Re: Petition No. 1484 – Modifications to Gales Ferry Substation

Responses to CSC-01 Interrogatories, dated February 22, 2022
CSC-01 through CSC-013.

PROFILE C-C
 HORIZ. SCALE: 1"=10'-0"
 VERT. SCALE: 1"=5'

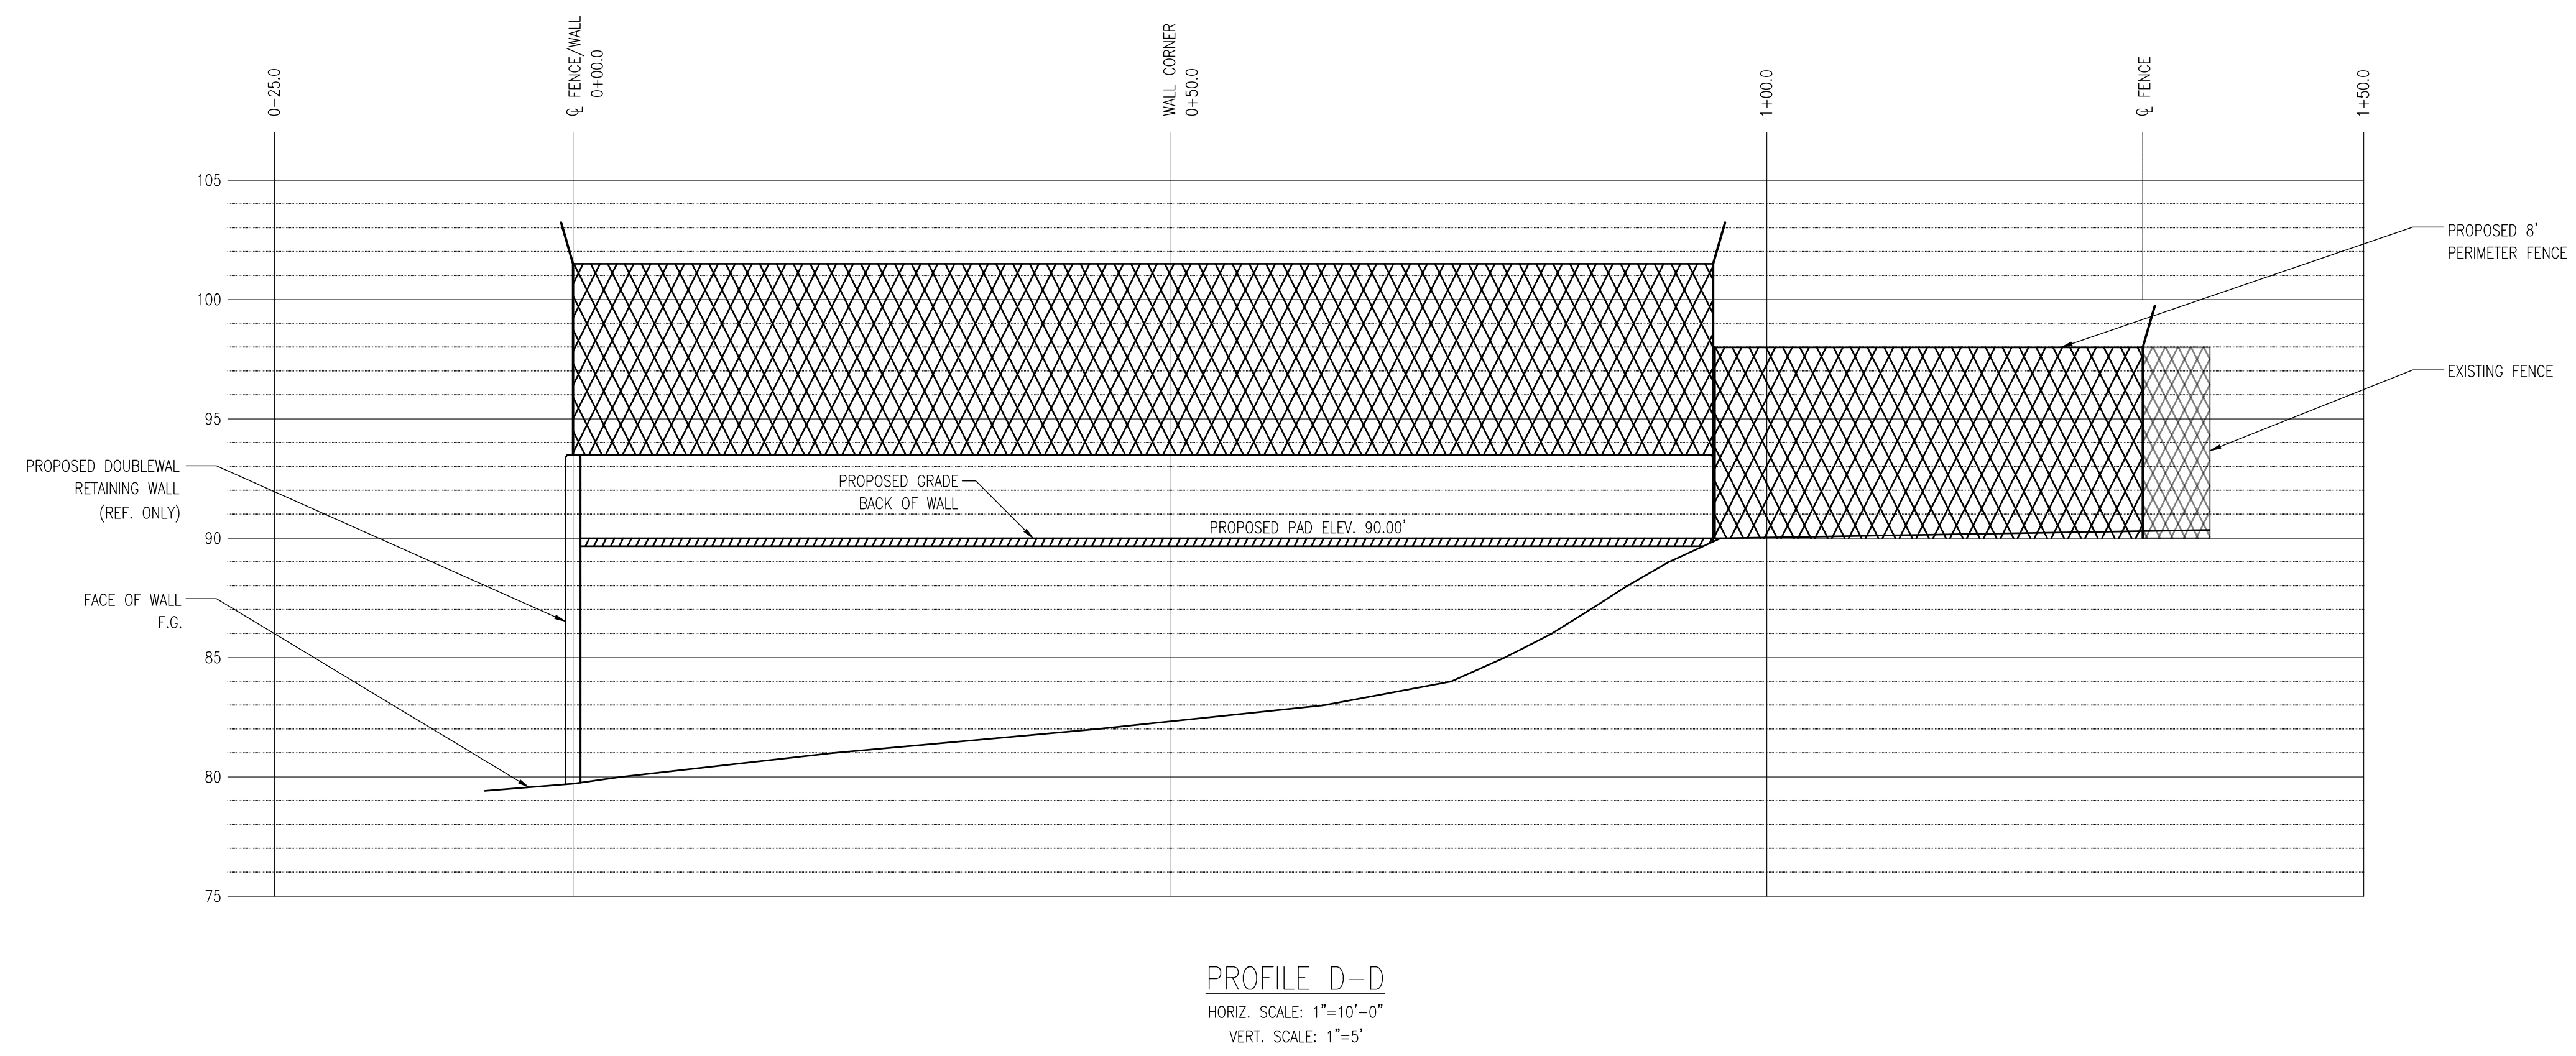
Provide a drawing of the proposed retaining wall.

Drawings showing a plan view and cross-sections of the retaining wall are attached.
